UNITED STATES PATENT AND TRADEMARK OFFICE

APPLICATION NO.	FILING DATE	FIRST NAMED INVENTOR	ATTORNEY DOCKET NO.	CONFIRMATION NO.
10/789,859	02/27/2004	Kent Ashby	15499.450.2	8490
22913 7590 06/21/2007 WORKMAN NYDEGGER (F/K/A WORKMAN NYDEGGER & SEELEY) 60 EAST SOUTH TEMPLE 1000 EAGLE GATE TOWER SALT LAKE CITY, UT 84111			EXAMINER TRAN, HANH VAN	
			ART UNIT 3637	PAPER NUMBER
			MAIL DATE 06/21/2007	DELIVERY MODE PAPER

Office Action Summary

DETAILED ACTION

Fig. 31

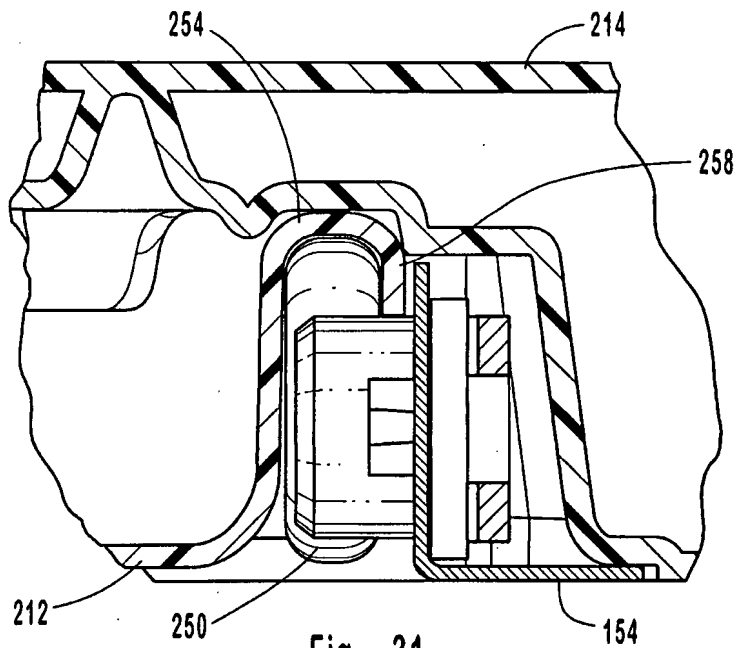
Acceptable!
HVT 6/8/08
